# 265 CENTRUM

CITY COMMENTS RESPONSE

January 12, 2024

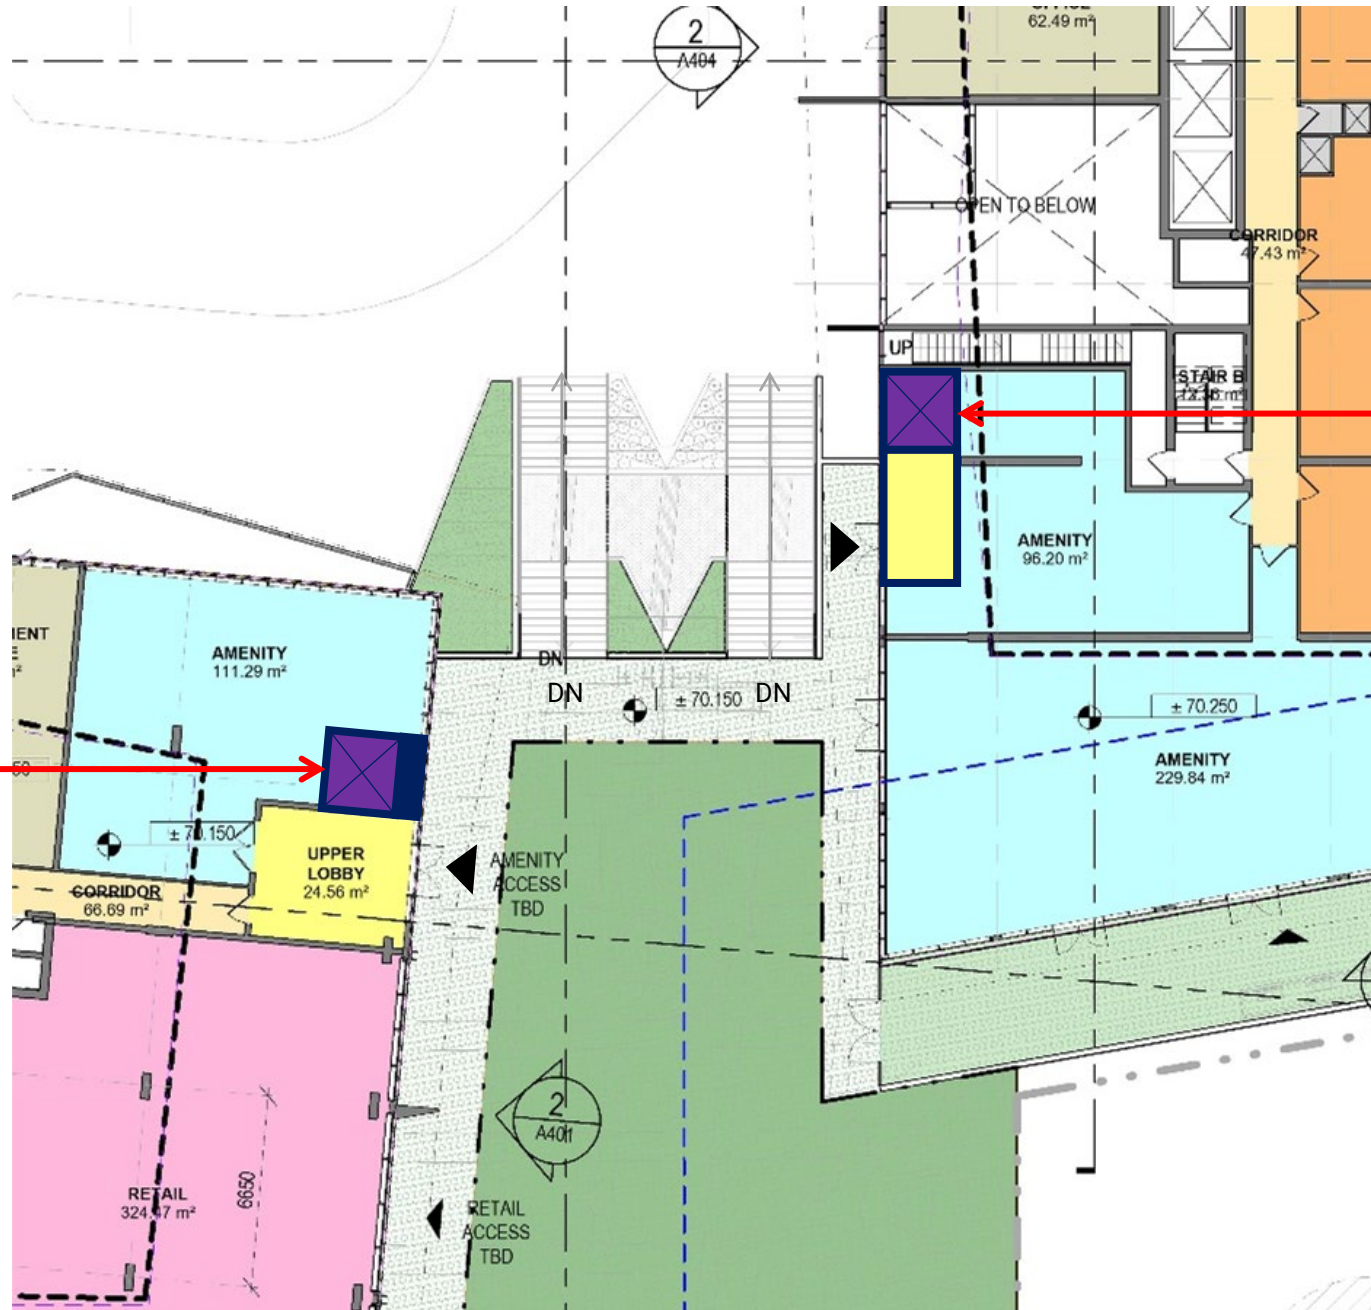
- 4.8. The pre-consultation comments noted the need for an AODA compliant pedestrian connection from Centrum to the entries of Towers B and C. Neither the pre-consult concept, nor the concept of September 2022 suggested that this would not be possible (both images below).

The current submission shows a significant staircase, which is in no way accessible. People living in Tower C, who may use wheelchairs, canes, walkers, strollers etc. will be required to go all the way around Brisebois to get to any uses on Centrum, including bus service.

The plan needs to be reworked to include an AODA compliant connection, as clearly noted in the original pre-consult comments provided in Spring 2022.
